**Re: Mansfield Ski Club  
Community of Mansfield, Township of Mulmur,  
ECA Reference No. 8664-BZVSYN  
Contingency Plan  
WMI File No. 15-319**

The following is a formal response to your email dated July 8, 2021 which requested a technical memorandum related to the discrepancy between Maximum Daily Sewage flows referenced within the approved Assimilative Capacity Study dated May 2018 and the Site Servicing & Stormwater Management Report dated April 2021.

**FLOW BALANCING CALCULATIONS  
 SEWAGE TREATMENT SYSTEM DESIGN**

**Mansfield Ski Club**  
**BIOFILTER PLAN 1**

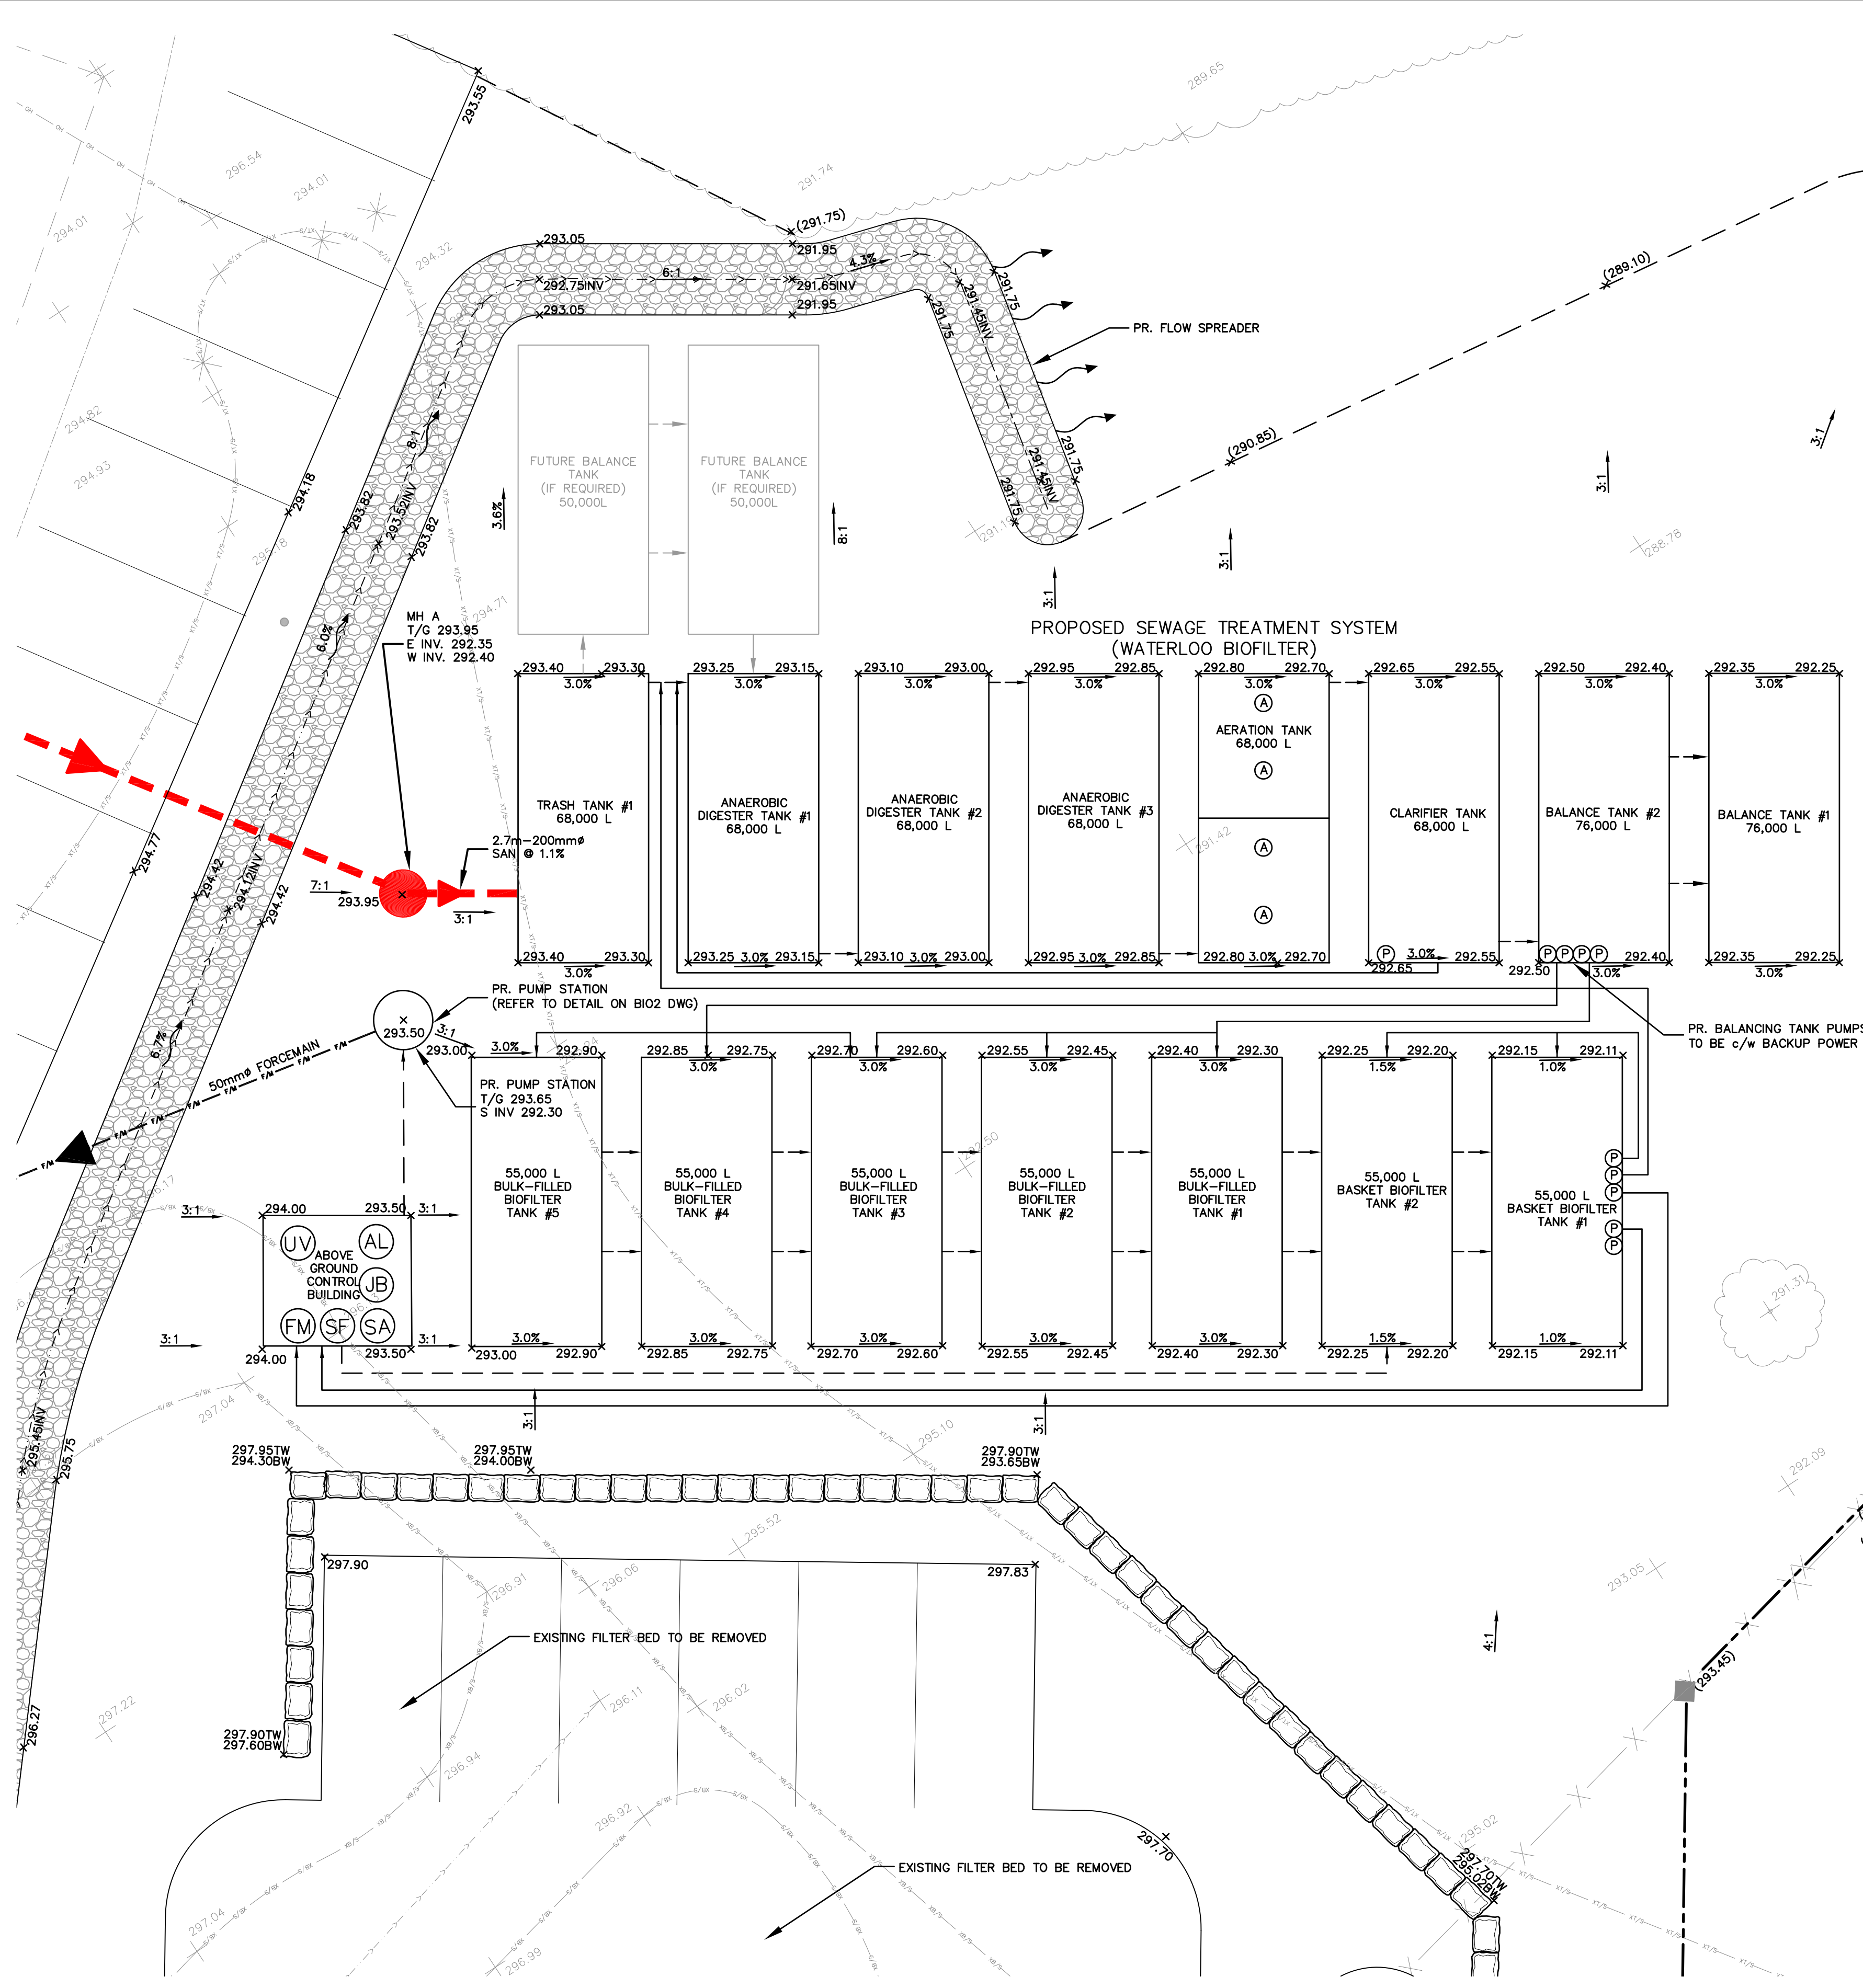
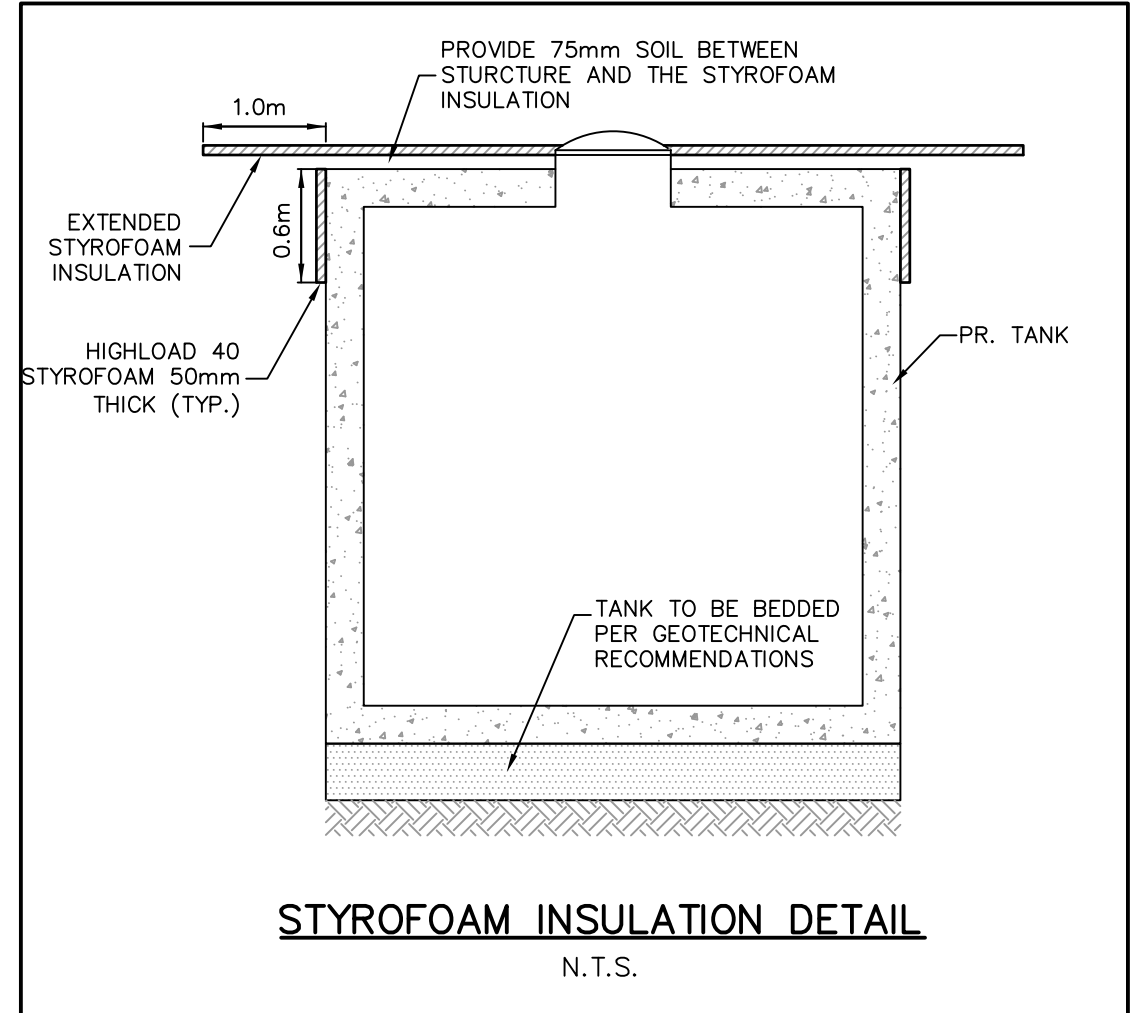
Our approach is to closely monitor flows as construction is phased in and more of the proposed facilities become occupied. If flows remain below the allowable discharge rate of 120,387L/day (1.39L/s) flow balancing will not be implemented. On the other hand, in the event that flow monitoring data suggests that additional build-out of the proposed development may result in an exceedance of the allowable discharge rate to the Pine River, flow balancing will be implemented at the upstream end of the sewage treatment system in order to maintain the allowable discharge rate.

Based on a review of monitored flow data as noted above, should it be determined that 50,000L or less of flow balancing is suffice, only one (1) of the proposed balancing tanks will be installed. Otherwise, if the monitored flow data warrants greater than 50,000L of flow balancing, both tanks will be installed as outlined on the Biofilter Plan 1 (BIO1). Refer to the attached **BIO1** drawing and supporting flow balancing calculations for additional details.

- BALANCING TANK PUMPS TO BE COMPLETE WITH A STANDALONE WATERLOO SMART PANEL AND BACKUP POWER.
- DURING A SYSTEM FAILURE OR POWER OUTAGE, DOMESTIC WATER SUPPLY WILL BE SHUT DOWN.
- BALANCING TANK MAXIMUM CAPACITY IS 152,000L (POTENTIALLY AVAILABLE).
- SEPTIC CONTRACTOR TO PUMP OUT AND DISPOSE OF PARTIALLY TREATED EFFLUENT FROM WITHIN THE BALANCING TANKS (IF NECESSARY).
- 363,895L OF STORAGE IS AVAILABLE WITHIN THE SEVEN (7) BIOFILTER TANKS (2.7 DAYS WORTH) WHICH CAN BE UTILIZED VIA THE BALANCING TANK PUMPS BACKUP POWER (IF NECESSARY).
- SEPTIC CONTRACTOR TO PUMP OUT AND DISPOSE OF ANY PARTIALLY TREATED EFFLUENT WITHIN THE BALANCING/BIOFILTER TANKS PRIOR TO RESUMING NORMAL OPERATIONS IF THE EFFLUENT LIMITS THROUGH RESIDUAL TREATMENT PROCESSING CANNOT BE ACHIEVED.
